### REMARKS

## **AMENDMENTS TO THE DRAWINGS:**

APPLN NO.: 10/629,738
Amdt. Dated: September 27, 2004
Reply to Office Action of: May 27, 2004
ANNOTATED SHEET SHOWING CHANGES

FIG. 3

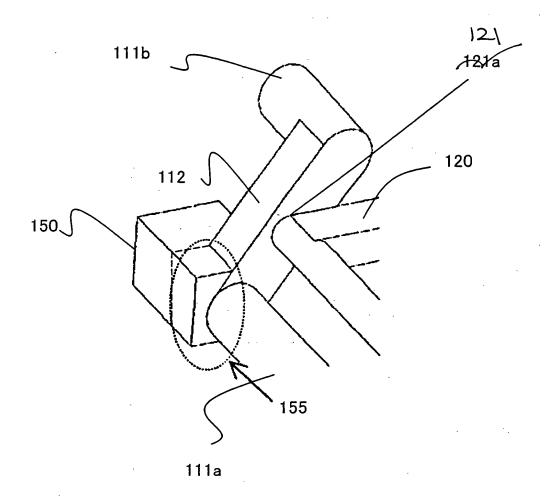
The Examiner has objected to the drawings as failing to comply with 37 CFR §1.84(p)(5) as they do not include reference numerals 502a, 121, and 614 mentioned in the description. Further, the Examiner has objected to the drawings as failing to comply with 37 CFR §1.84(p)(5) as reference numeral 502b is not mentioned in the description.

In order to overcome the above objections, Figure 3 has been amended so that reference numeral 121a is now reference numeral 121 as being consistent with the description provided on page 9. Figure 6 has been amended so that reference numeral 502b is now reference numeral 502a as being consistent with the description provided on page 1. Finally, Figure 7 has been amended to delete the reference numeral 614.

The attached drawings include changes to Figures 3, 6, and 7. In particular, Figures 3 and 6 have been amended to correct reference numerals and Figure 7 has been amended to delete a reference numeral.
